Board of Architectural Review

DATE: December 20, 2023
TO: Board of Architectural Review Chair and Members
THROUGH: Jason Sutphin, Community Development Division Chief JDS
FROM: Anna Kohlbrenner, BAR Liaison AK
SUBJECT: **Public Hearing: 10306 Eaton Place – Willow Wood**

1. Case Number:	BAR-23-00041
2. Address:	10306 Eaton Place
3. Request:	Mixed-use building
4. Applicant:	Capital City Real Estate LLC
5. Applicant's Representative:	Evan Pritchard
6. Status of Representative:	Attorney
7. Zoning:	CR Commercial Retail, Architectural Control Overlay District

BOARD OF ARCHITECTURAL REVIEW
MAJOR APPLICATION SUBMISSION
CITY OF FAIRFAX

1 WEST ELEVATION

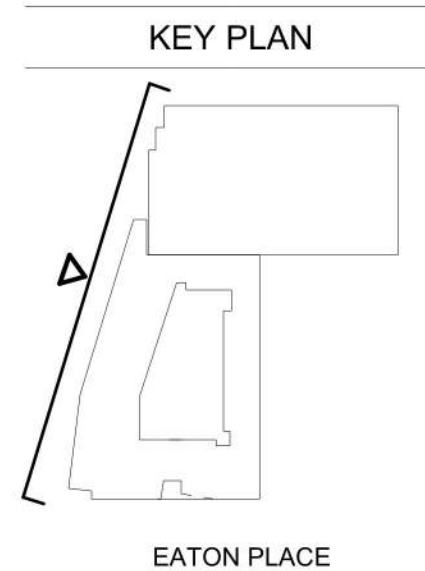
west elevation, but he would still like to see more variation. He stated it is very flat and deserves some additional fenestration changes. He stated he liked the retail expansion in the west elevation. He stated his comments are consistent with his previous comments at the previous work session. He stated looking back at Pathela's comments, he knows he will want some change on the façade.

1 EAST ELEVATION

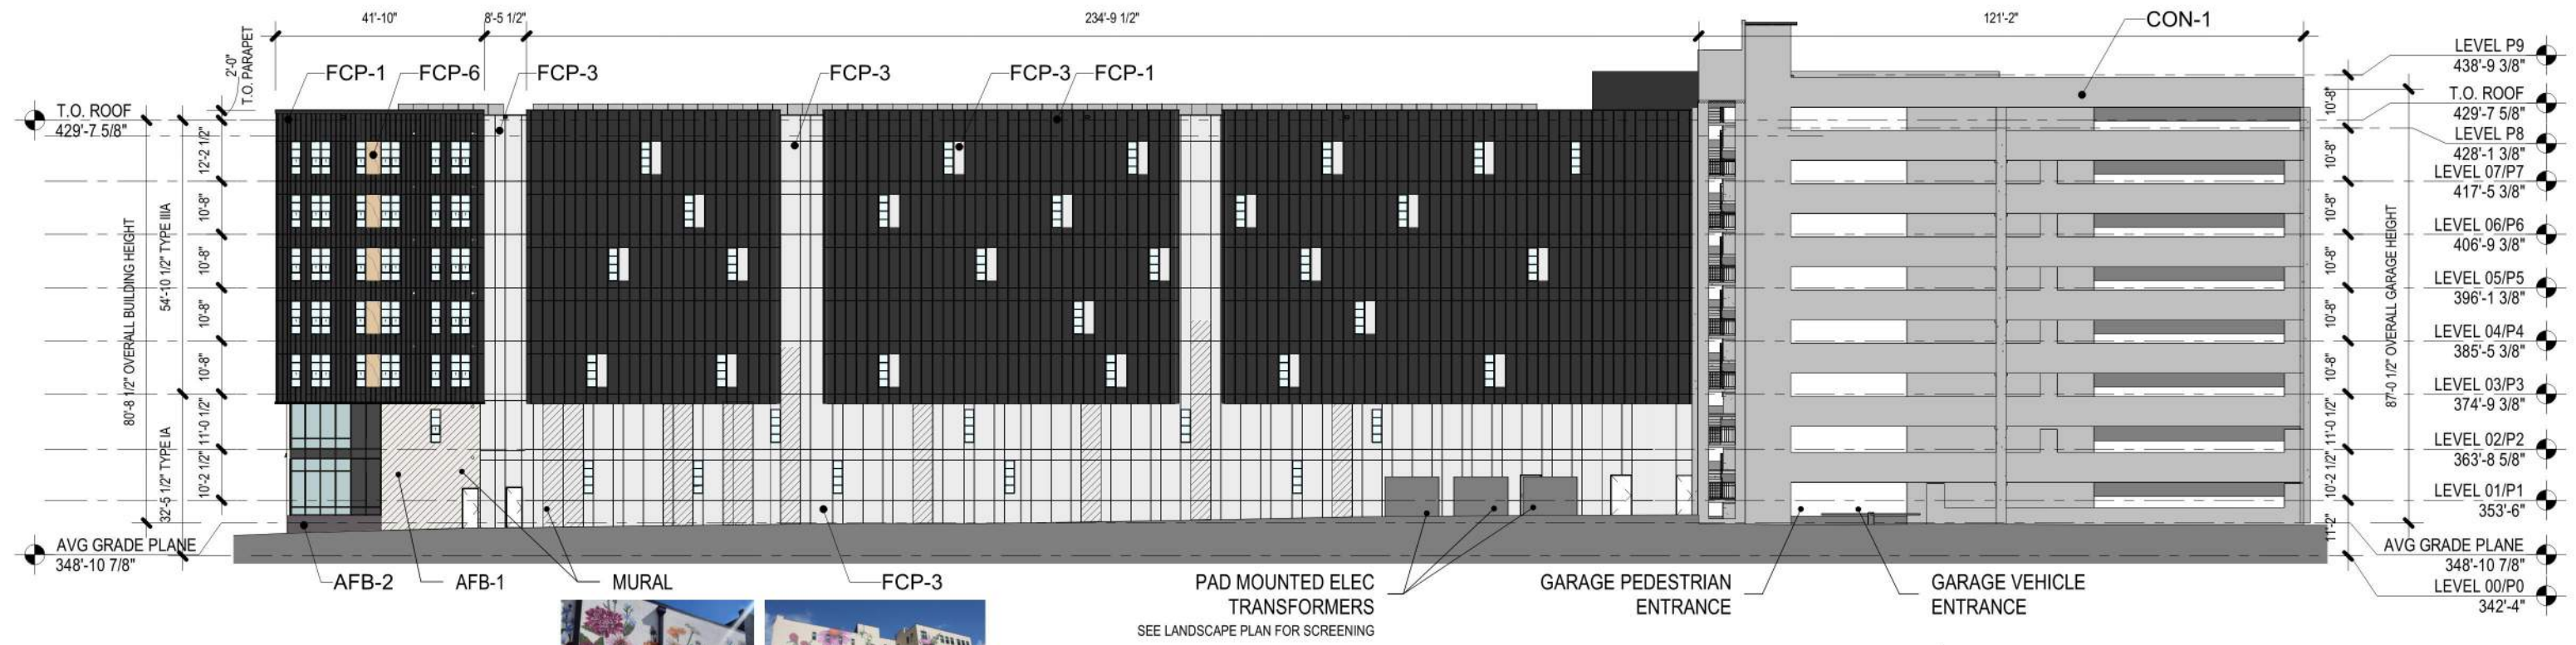
The applicant is not proposing varying bays to break up very large massing. The building is tall and boxy, with very little visual interest. Driving west down Eaton Place, the proposed building wall on the east has no interest at the pedestrian level with little to no windows, on the eastern building wall.

The human scale is not reinforced in this design. The building size appears overwhelming, without a change in material at the pedestrian realm. The building width along the east side is approximately 275' wall of fiber cement panel with little to no windows and a precast concrete parking garage, which does not engage pedestrians or drivers in any way. Portions of the parking garage are visible from Eaton Place. The applicant should look at treatments to screen it. The building width along the west side is approximately 300', not including the parking garage section, which is a long wall of repetitive windows and fiber cement material and some brick from the first to second story. The western building wall shows repetitive utilitarian balconies. The building scale along Eaton Place shows repetitive windows, with little character and sense of place.

The applicant is not proposing a different foundation material on the east and west sides of the building. Staff recommends using separate foundation material on east and west sides as well, in addition to continuing a different color brick or material along Eaton at the foundation line.

The applicant is proposing brick on the west and south sides of the building but only up to the second floor. The east side of the building does not have brick, only fiber cement and concrete. The applicant shall add varying material bays throughout while adding more masonry material.

Waye suggested changing the material from fiber cement paneling to metal paneling on the east elevation. She stated that could complement the mural, which would enhance that wall, without fenestration. She asked what type of seam the board and batten would have.
